Development Review Hearing

**Item 2 : PLN25-00295
2892 Mesquite Drive**

December 10, 2025

- **Architectural Review** for a 621 square foot first floor addition and a 397 square foot second floor addition to an existing two-story 2,081 square foot single-family residence with a 500 square foot attached garage
- Per SCCC 18.120.020(D)(1), the request to expand an existing second story element requires Architectural Review approval through a Development Review Hearing.

PROPOSED FLOOR PLAN
SCALE: 1/4" = 1'-0"

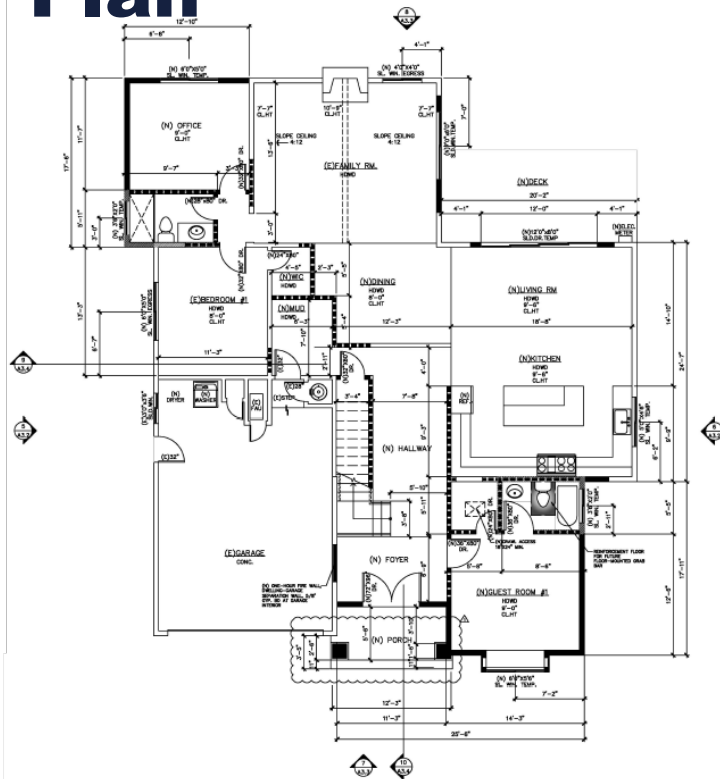
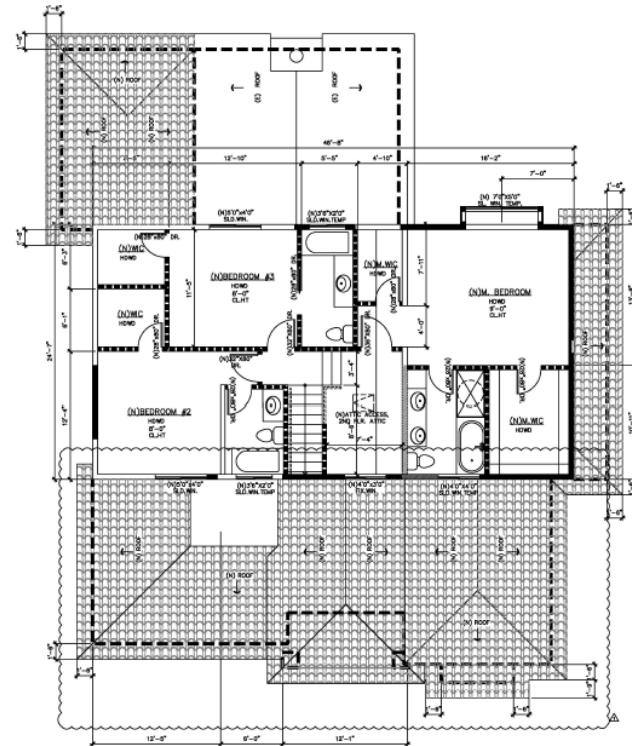
The proposed project doesn't comply with the City's Single-Family and Duplex Residential Design Guidelines (2014), in that:

- The proposal's height and bulk is not appropriate relative to the neighborhood.
- The proposal doesn't adhere to the prevailing development pattern in the subdivision.
- The proposal has scale, shadow, view, and light impacts to the adjacent property.

- **Front Yard Landscape:** Bushes and code-compliant hedges shall be added to the front yard
- **Guest Bedroom Setback:** The guest bedroom shall adhere to the prevailing development pattern by providing a greater front and side setback.
